METROPOLITAN GOVERNMENT OF NASHVILLE AND DAVIDSON COUNTY

STAFF RECOMMENDATION
1501 Linden Avenue
December 16, 2020

Application: New Construction—Addition
District: Belmont-Hillsboro Neighborhood Conservation Zoning Overlay
Council District: 18
Base Zoning: R8
Map and Parcel Number: 10513008500
Applicant: Martin Wieck, Nine-12 Architects
Project Lead: Sean Alexander, sean.alexander@nashville.gov

Figure 3: Proposed new East Elevation for 1501 Linden Avenue.

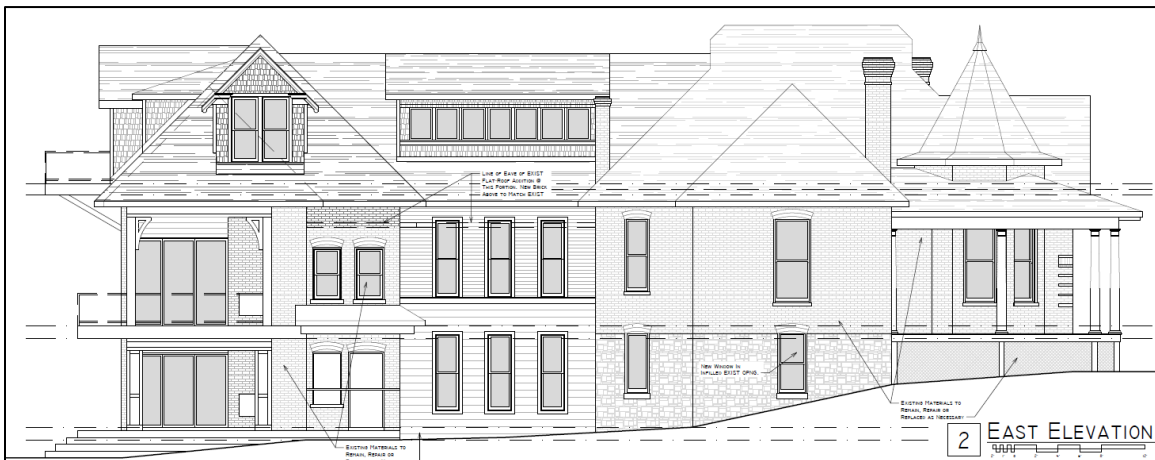
On the left side, a projecting balcony will be added at the main floor level, wrapping around the left side of the addition to the rear. Staff finds that the additional width of the balcony to the left is not appropriate, as the addition is also going wider to the right. The portion of the balcony on the rear is appropriate, as is an upper-level balcony that is stepped in fifteen feet (15') from the left side and twenty-seven feet (27') from the right.

The eaves of the addition will match the eave height of the historic house, with a gable roof tying into the rear slope of the historic roof two feet, eight inches (2'-8") below the original hip-ridge. A hipped component of the addition's roof will rise twenty-two inches (22") up at the rear. With matching eave height and a roof ridge eleven inches (11") shorter than the original roof, Staff finds the heights of the proposed addition to be appropriate.

A gable ridge is connecting between the original hipped roof and the hipped component of the addition. On the right side, this gable steps in more than six feet (6') from the side slope of the roof, which differentiates it and preserves the original form. On the left side, the gable is not stepping in. Additions have typically been required to step in from the sides of an historic roof form to differentiate the new construction and preserve historic forms. By not stepping in, the rear hip-ridge is inappropriately destroyed.

The left slope of the gabled connector between the two hipped roofs also contains a shed-roofed dormer. While shed roofs are common throughout the surrounding area, the historic house comprises only hip and gable forms. Staff finds that the introduction of a shed form is not compatible with this historic house.

With a condition that the projecting balcony is removed from the left side, Staff finds that the height and scale of the proposed addition meets sections II.B.1a and II.B.1.b of the design guidelines.

With a condition that the gabled connector between the two hipped roofs is stepped down from the primary roof on the left side; that the form of the dormer on the connector is compatible with the form of the original roof or removed; and the street-facing dormer is removed or its width shortened so it does not extend beyond the point of the front-right chimney, staff finds that the roof forms of the addition are compatible with the historic house and meet section II.B.1.e of the design guidelines.

ROOF PLAN

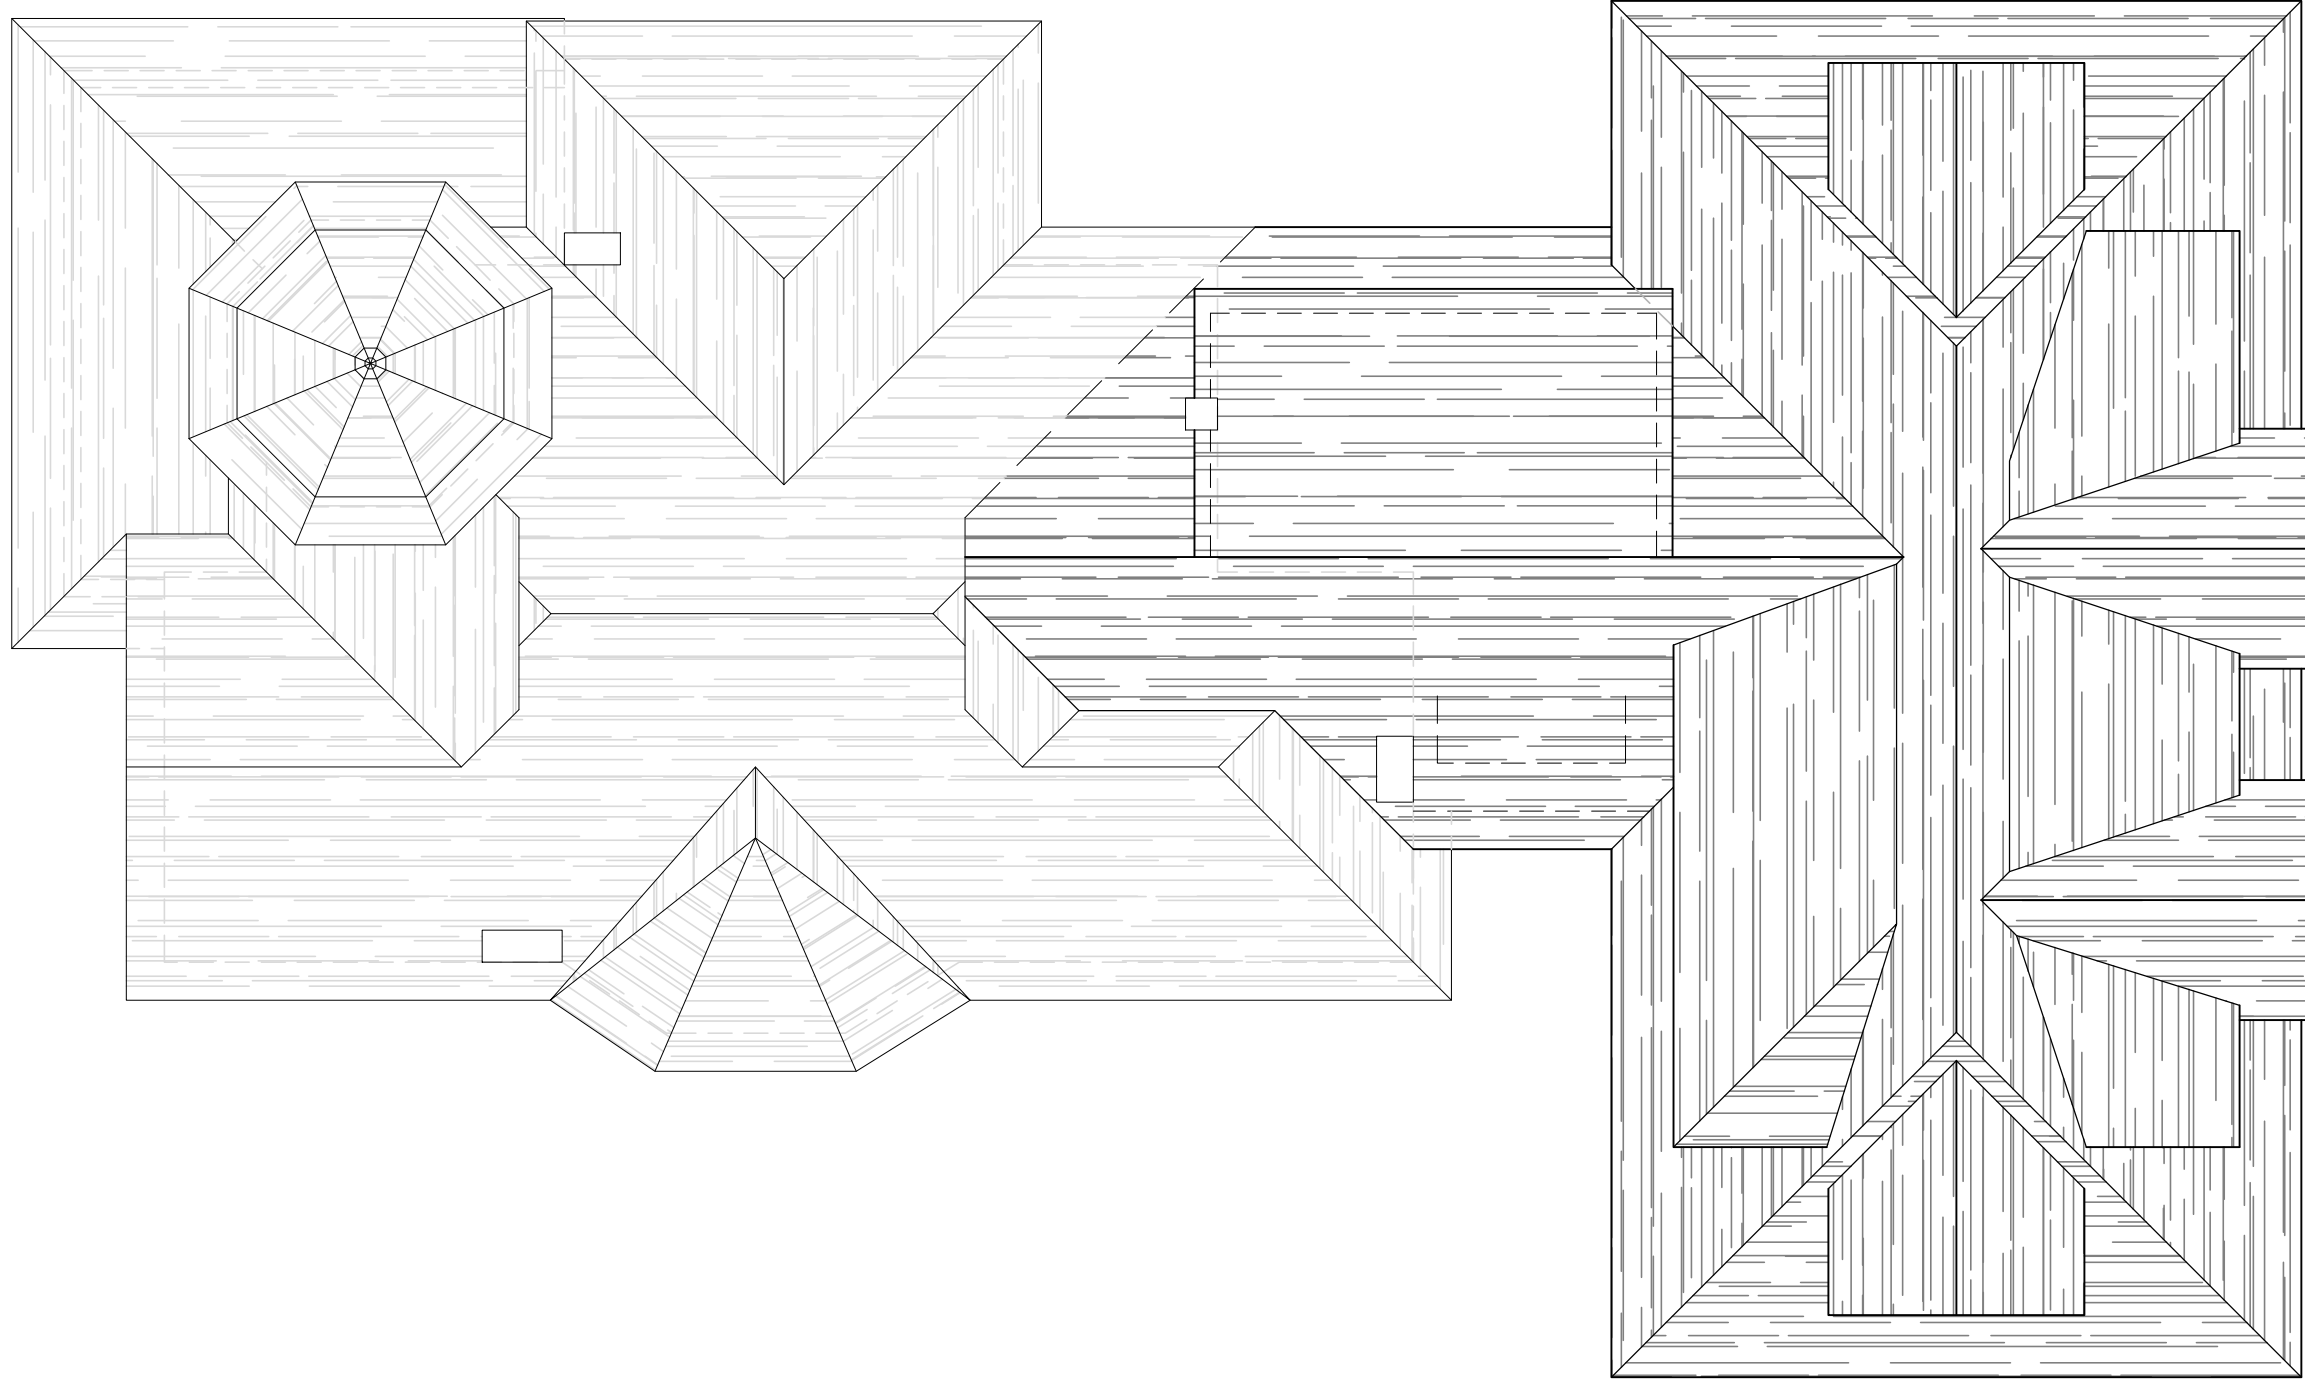
Roof form: The roof of the addition consists of a hipped primary mass, with the ridge perpendicular to the axis of the original hipped roof. The hipped roof has gabled dormers on the left and right slopes, and a hipped dormer on the front-facing slope of the wider portion of the addition to the right. The pitch and forms of these roofs match the original roof, which is hipped with hip and gabled projections.

The portion of the addition that goes wider to the right includes a large front-facing dormer. Staff recommends that this dormer be eliminated, as it makes the scale of the addition read as one and one-half story whereas the historic house reads as only single story. In the past, when additions have been approved to be wider than an historic house, the additions have kept to the number of stories as the house being enlarged in order to keep the scale subordinate. Another option would be to decrease the width of the dormer so that it does not extend further than the front-right chimney.

The rear slope of the roof will have a complex dormer with intersecting hip and gable forms. This dormer form is not typical, but because it is on the rear it will not have a significant impact on the historic character of the house. Even on corner lots where a rear elevation is visible, flexibility has typically been given to contemporary forms on additions and new construction.
